**SONY**  
Broadcast

maintenance and modification information for the one-inch line of Sony Broadcast Products

model: BVH-1000A / BVH-1100A

bulletin no.: 11

Figure 1

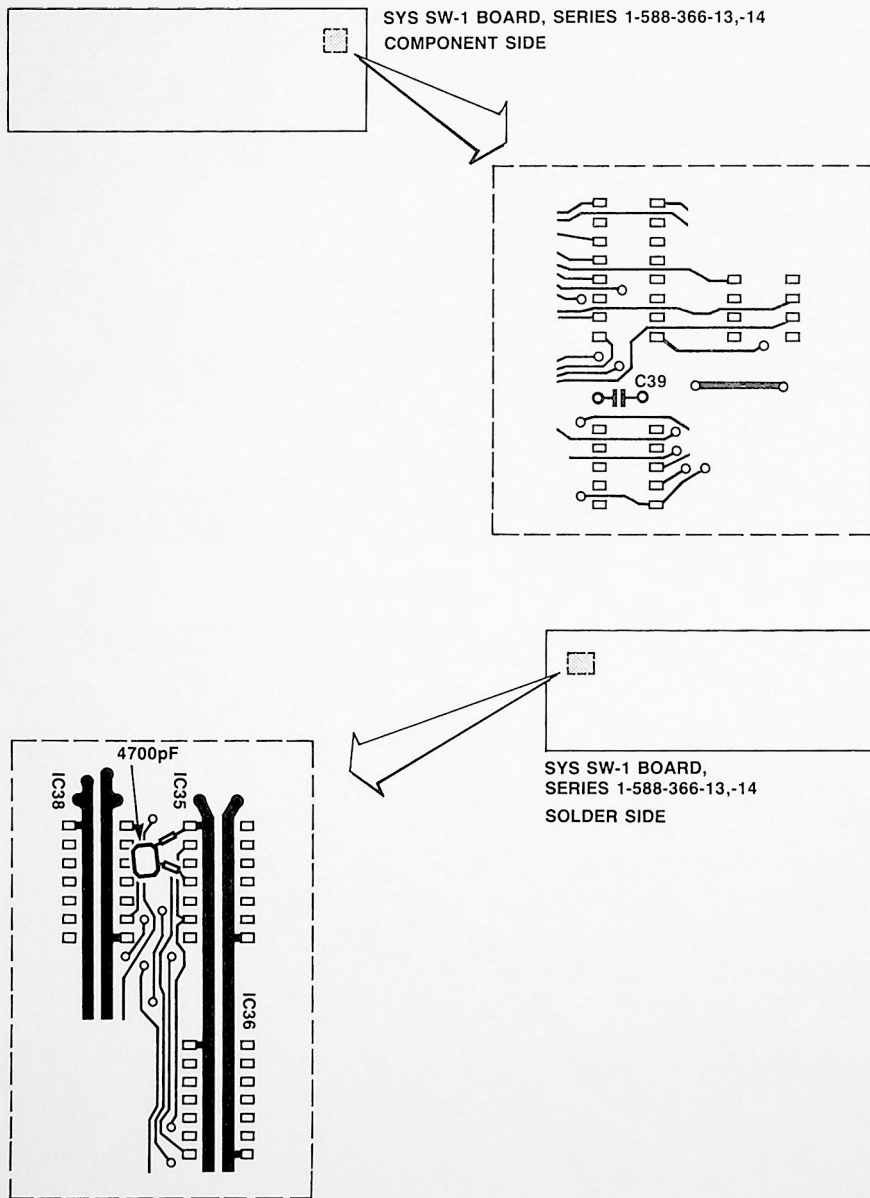
1. Remove C39 from its present position. (See Figure 1.)
2. Install 4700pF capacitor between IC35-4 and IC35-7.

Figure 1

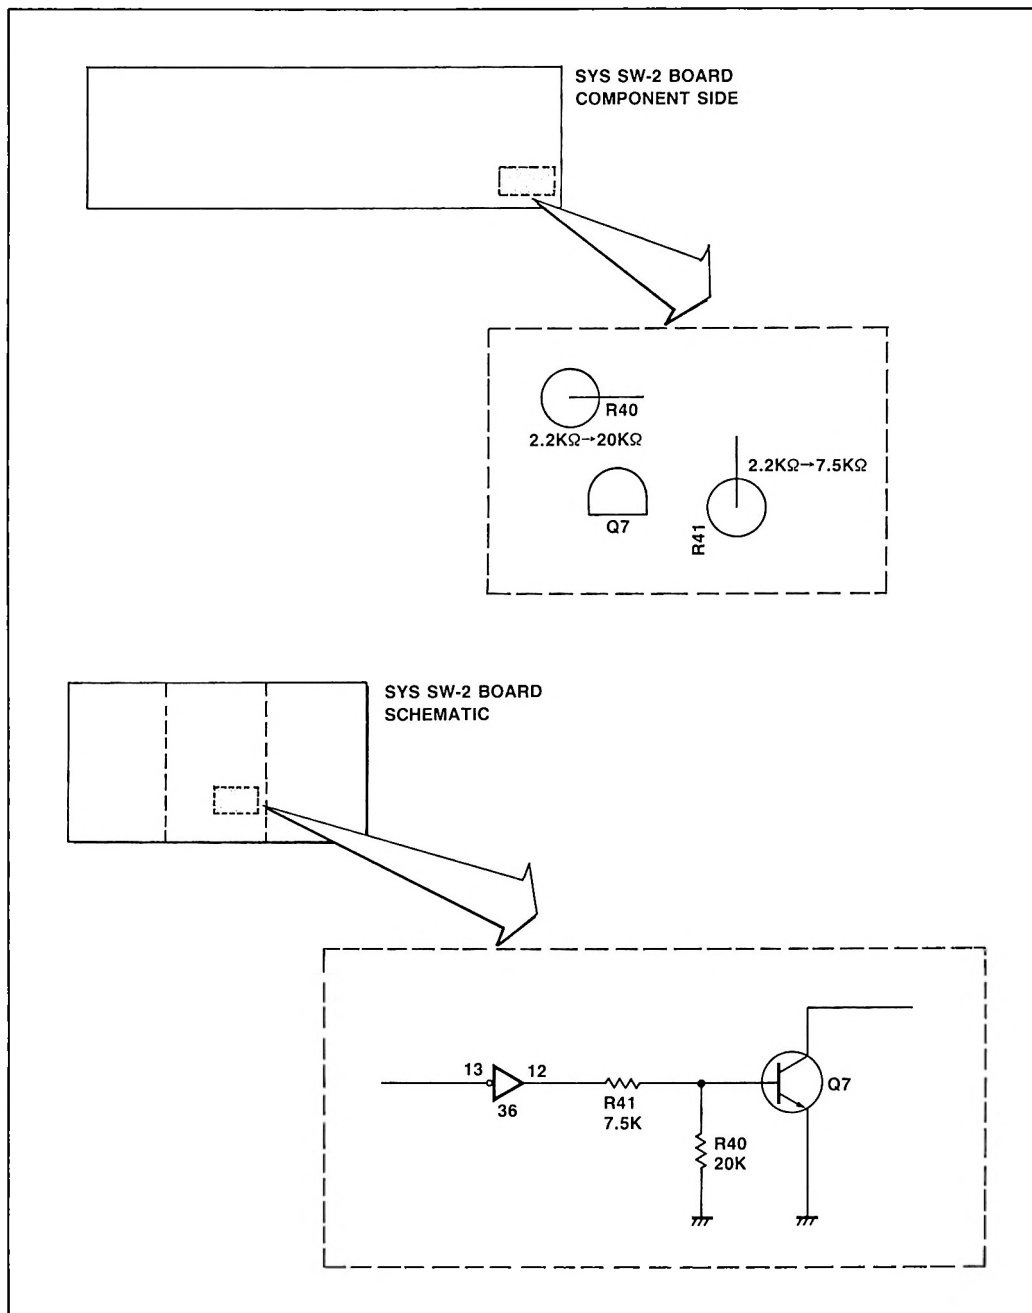
**MODIFICATION PROCEDURE****SYS SW-2 Board (Figure 1)**

1. Replace R40 with the 20k $\Omega$  resistor.
2. Replace R41 with the 7.5k $\Omega$  resistor.

Figure 1

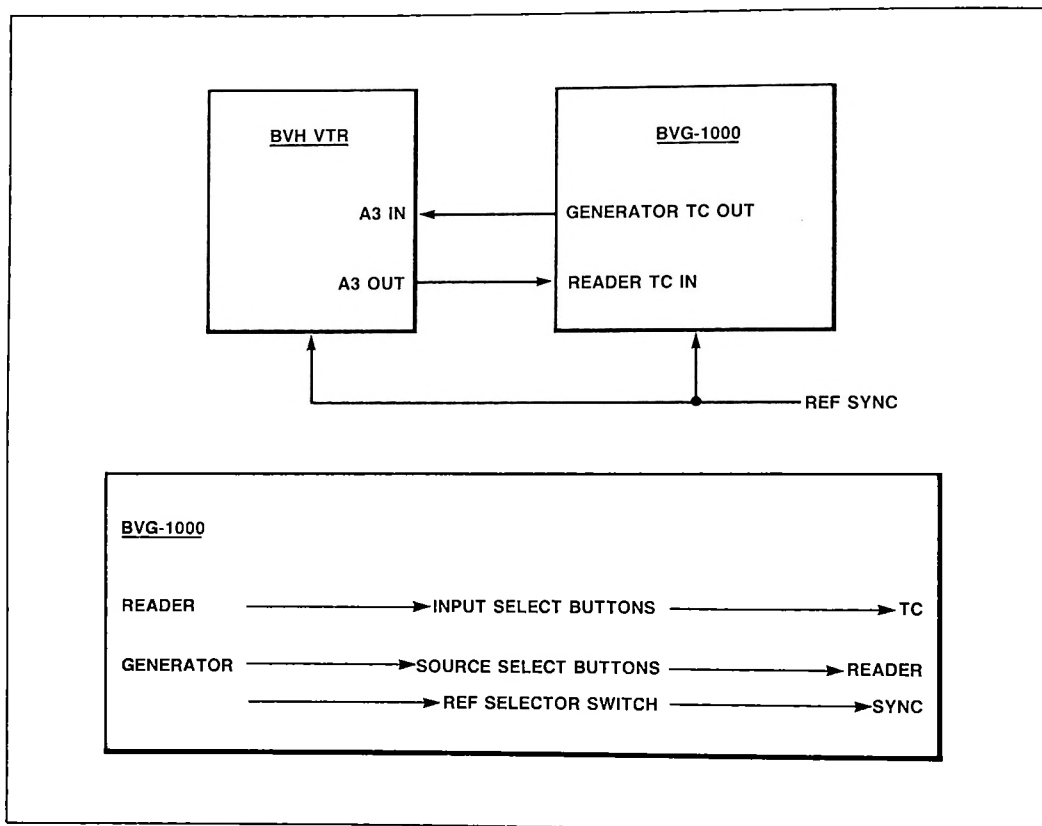
When performing Time Code Jam Sync with a BVH VTR and BVG-1000, as illustrated in Figure 1, a data error will occur at the assemble edit point. This error occurs because the audio output is muted for approximately 8 msec.

Figure 1

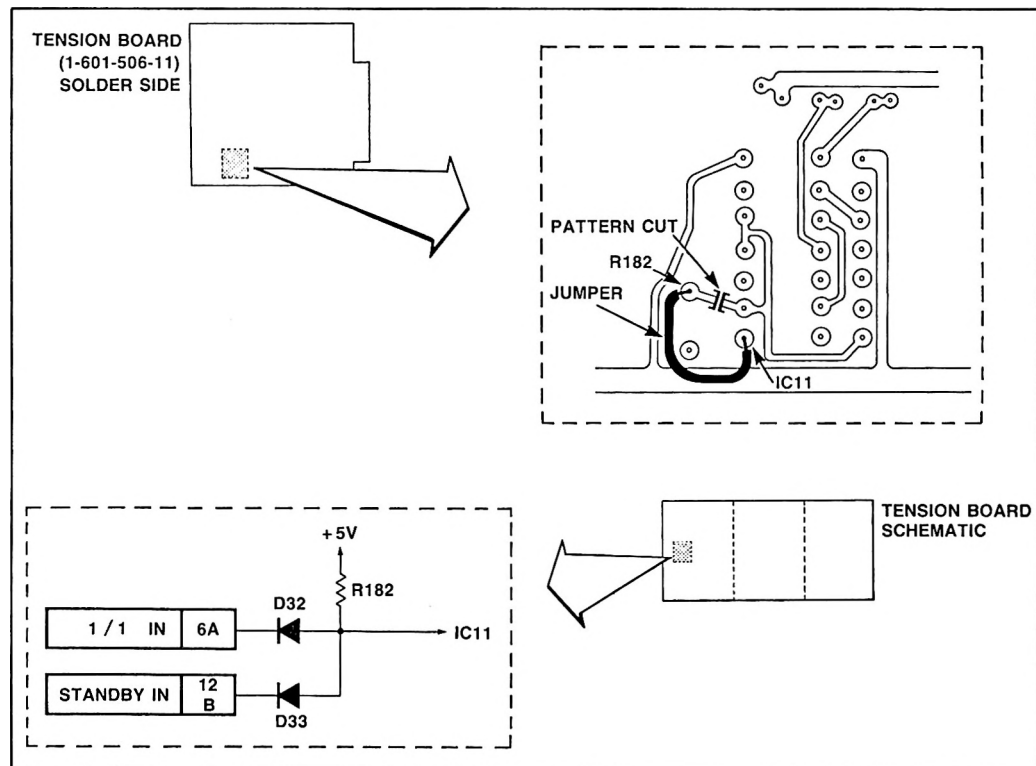
In the units listed above, an incorrect etching pattern on the Tension Board may cause malfunction of the Tension Motor drive circuits. The problem is a missing connection to +5V for pull-up resistor R182 (Figure 1). Tension motor drive is generated by NAND Gates in IC11. These gates are enabled by the output of AND Gate D32/D33. With no pull-up connection the output of D32/D33 becomes unstable when the inputs are high, and IC11 may be switched off by noise. The pattern cut and jumper connection shown in Figure 1 will eliminate the problem.

Figure 1

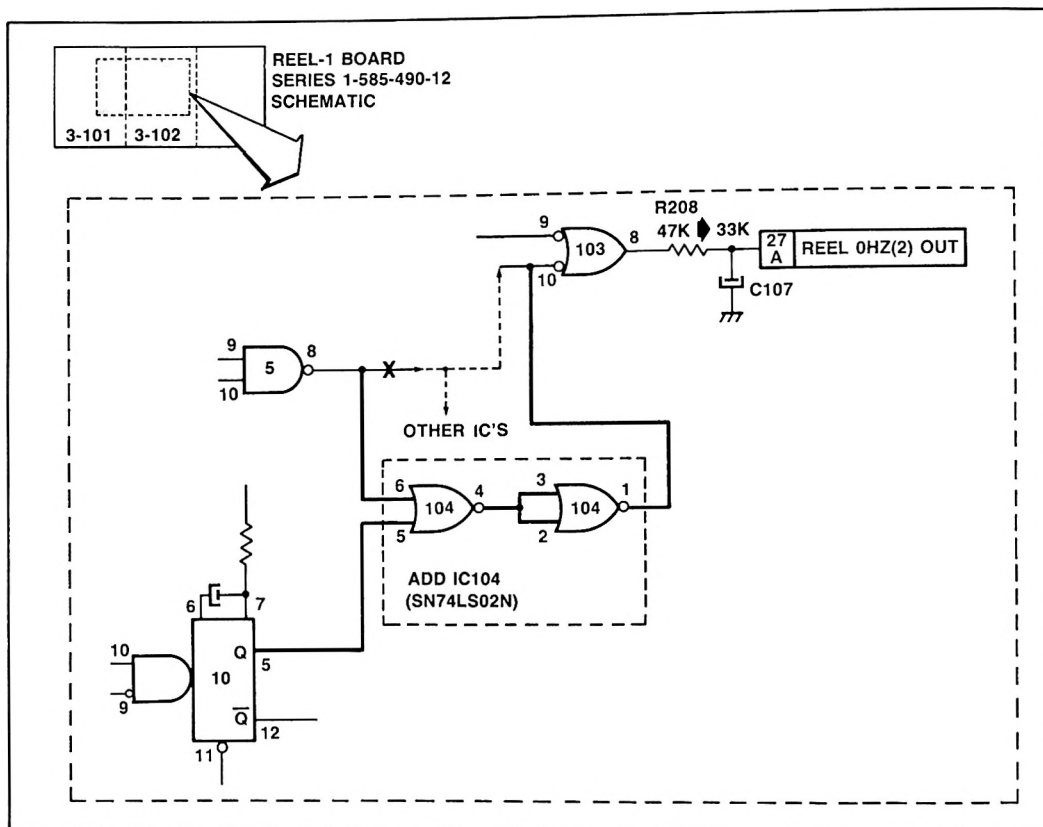
The following modification to the Reel-1 Board ensures that the capacitor will discharge by using a signal from the "Slow to FWD (1/1) Start Torque-up Booster" circuitry. Figures 1 and 5 show the modification schematics for Reel-1 Board series 1-585-490-12 and 1-600-679-11, -12, respectively.

Figure 4

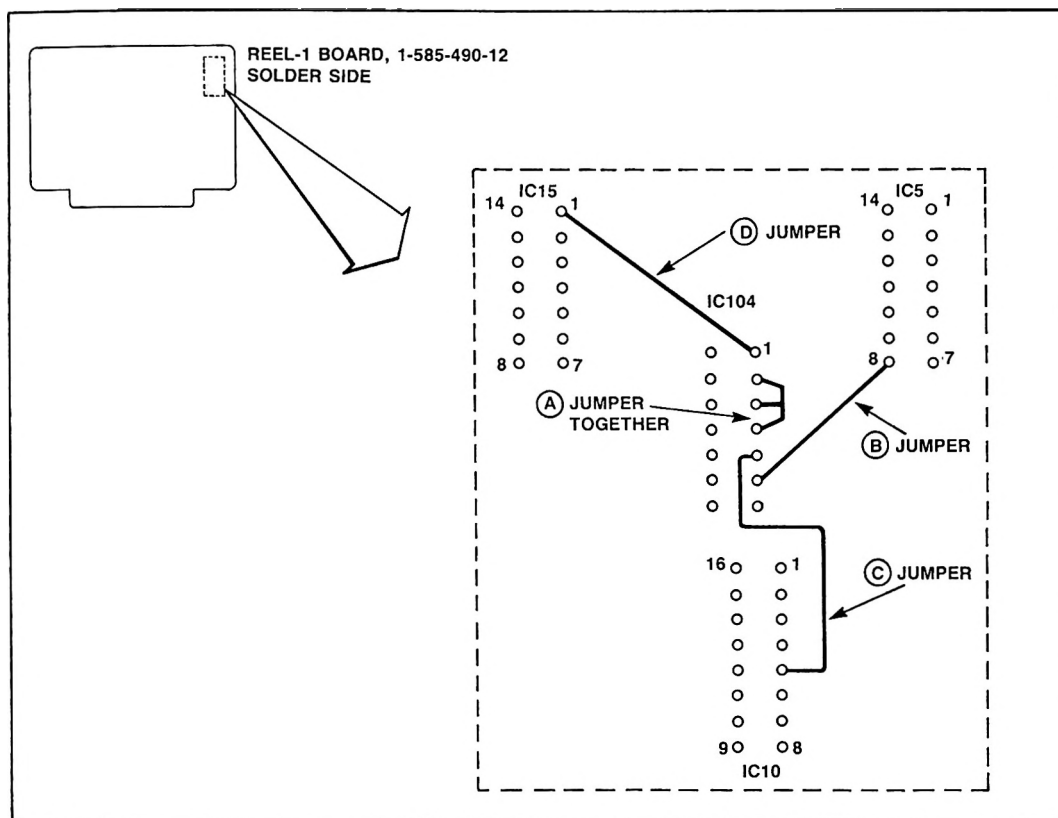
3. On solder side, cut trace at IC5-8. Cut should be made as close to pin 8 as possible. (See Figure 3.)
4. Add the following jumpers (See Figure 4.):

Figure 7

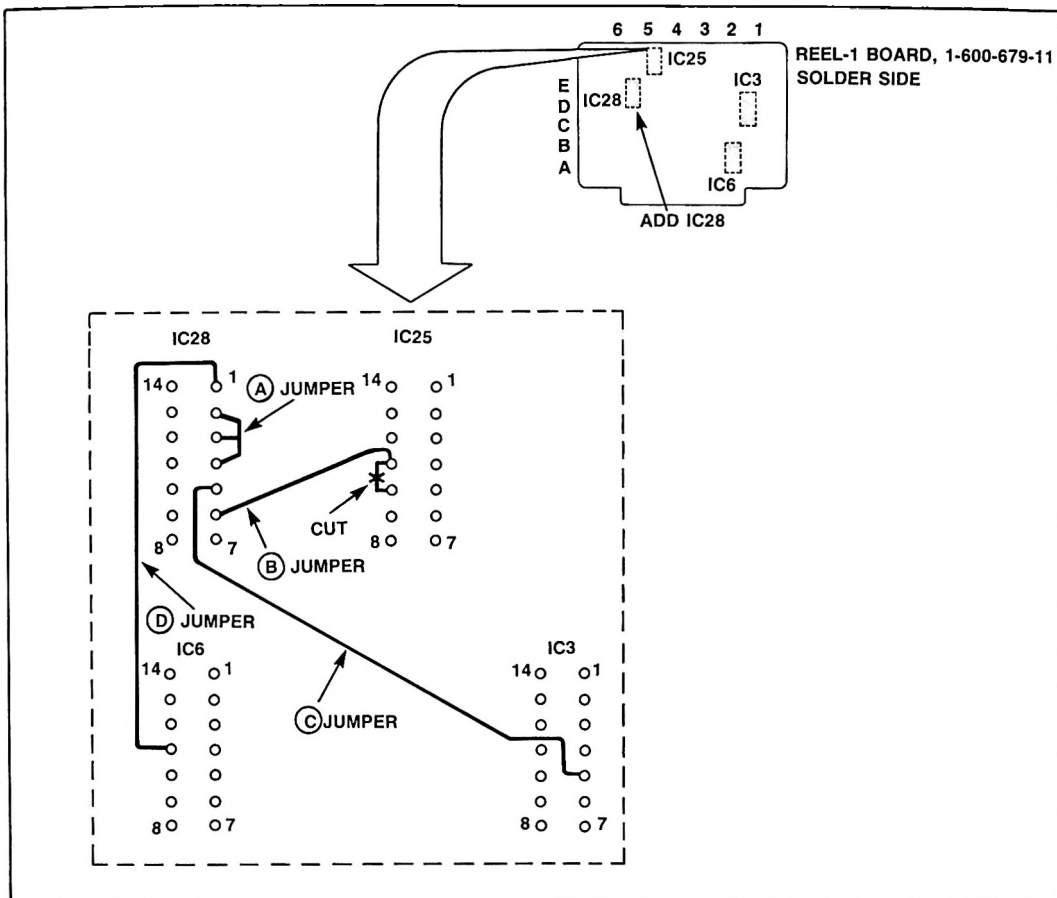
2. On solder side of board, cut trace at IC25-11. (See Figure 7.)
3. Install IC28 in unused area of the board. (See Figure 7.)
4. On solder side, add following jumpers (See Figure 7.):

Figure 2

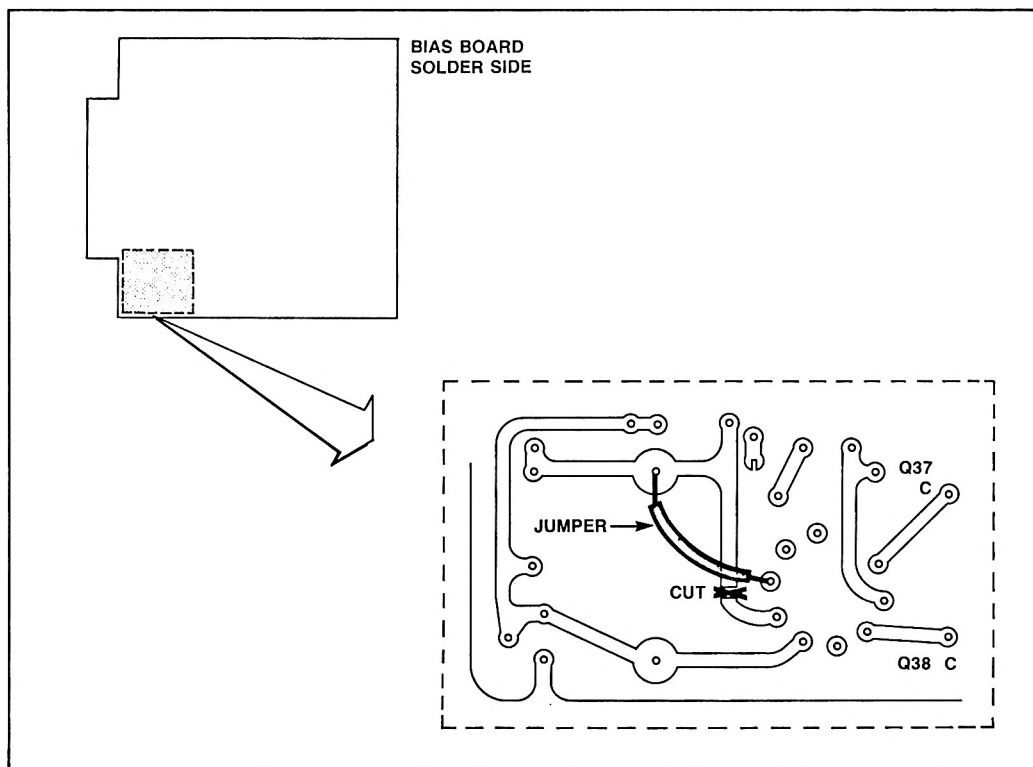
2. Cut trace to T8-6. (See Figure 2.)
3. Connect jumper between T8-7 and C59. (See Figure 2.)

Figure 1

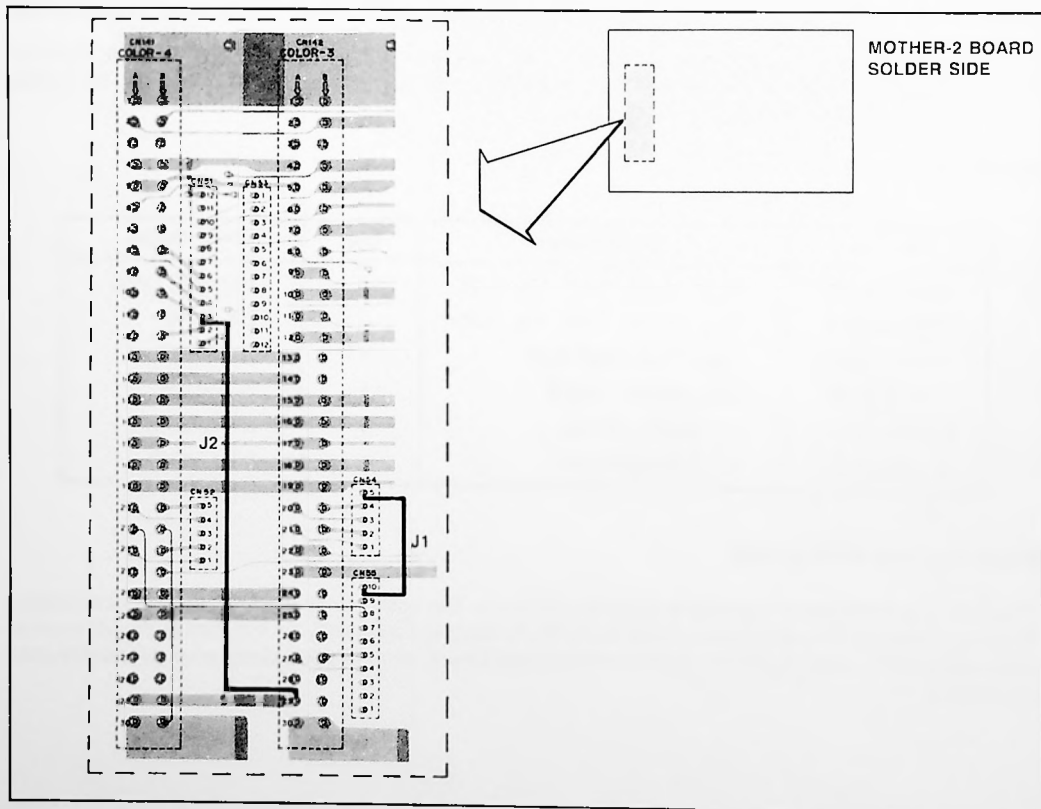
1. Prepare the following jumpers and solder them as follows. Figure 1 shows the jumper locations.

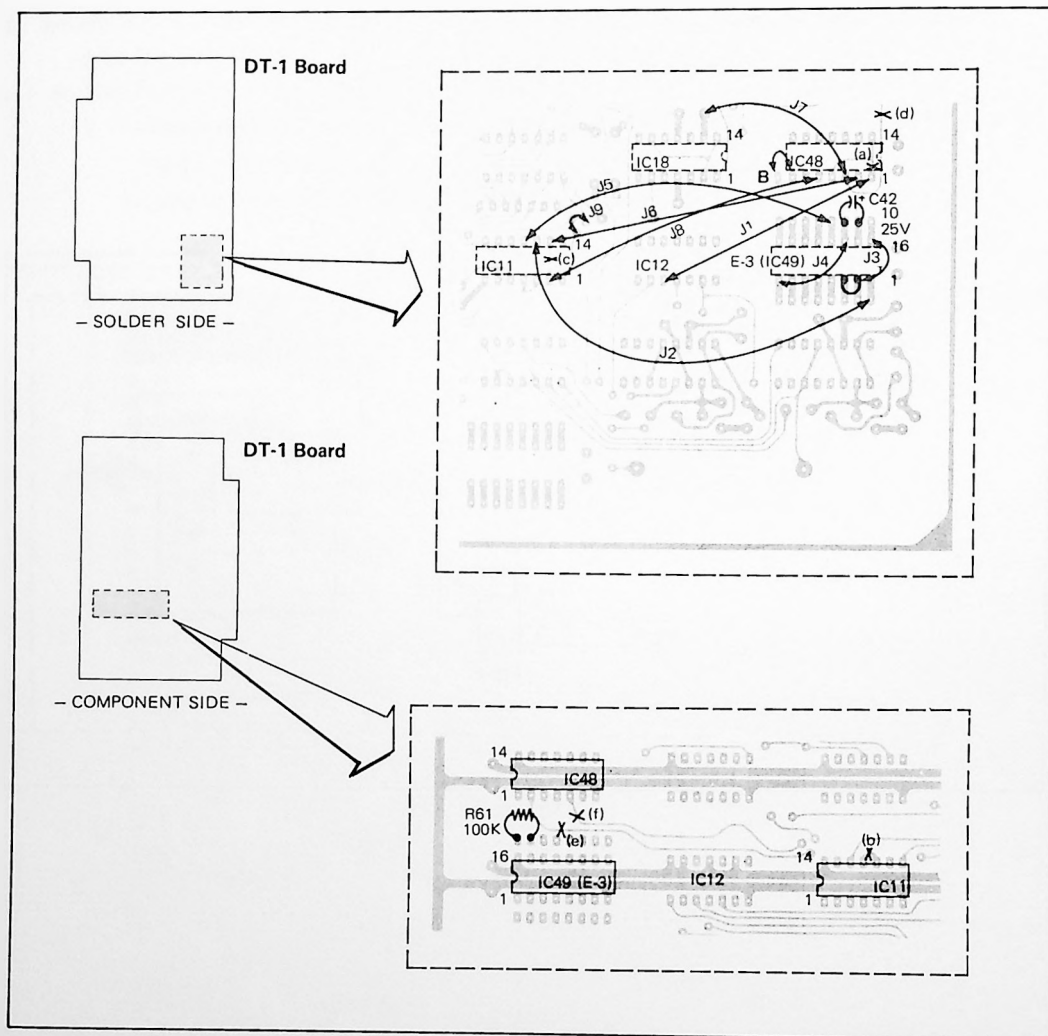
3. Prepare the following jumpers and solder them at the locations shown in Figure 3.

Figure 3

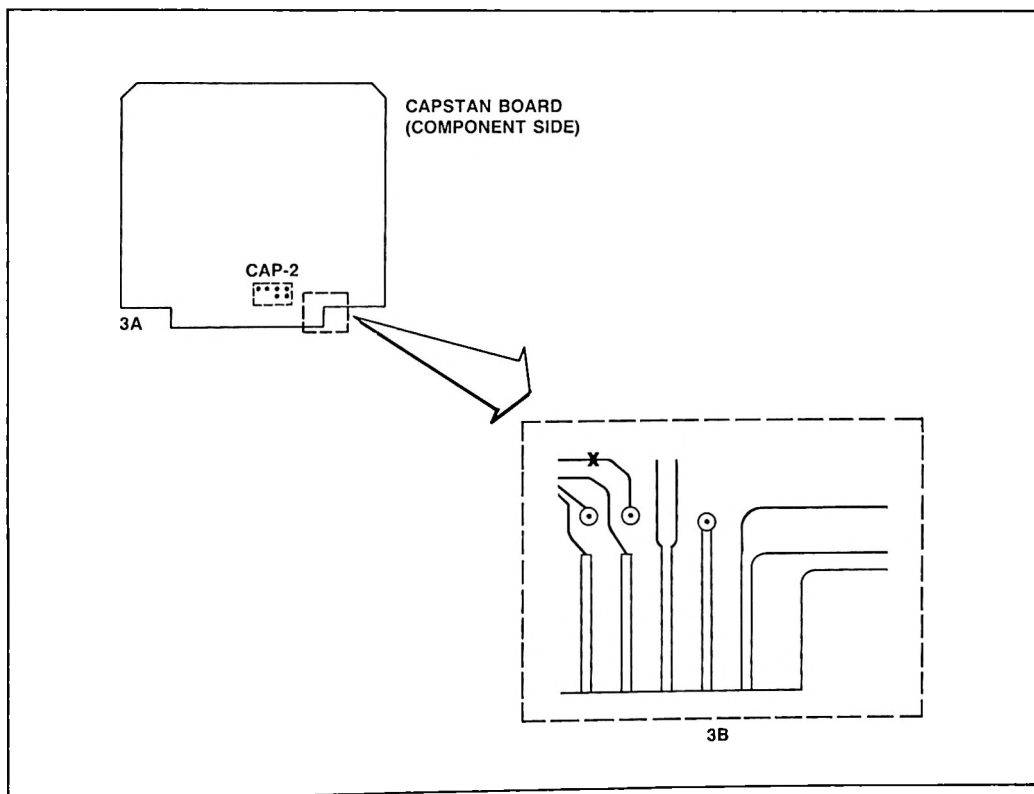
1. Mount the components and jumper wires on the new board as indicated in Figures 1 and 2.
2. Connect jumper wires as indicated in Figure 2.
3. Mount the new board on Capstan Board with double sided tape as indicated in Figure 3A.

1. Cut the trace between edge connector pin 4B and IC26-5 as indicated in Figure 3B.
2. Cut the trace between IC8-3 and IC32-5 as indicated in Figure 4B.
3. Add the 150KΩ resistor to IC43-2 and -6 as indicated in Figure 4C.
4. Add the 1.5μF capacitor to IC43-6 and ground as indicated in Figure 4C.
5. Jumper IC43-4 and -5 to IC27-8 (Ground) as indicated in Figure 4C.
6. Jumper IC43-3 to IC32-11 as indicated in Figure 4C.
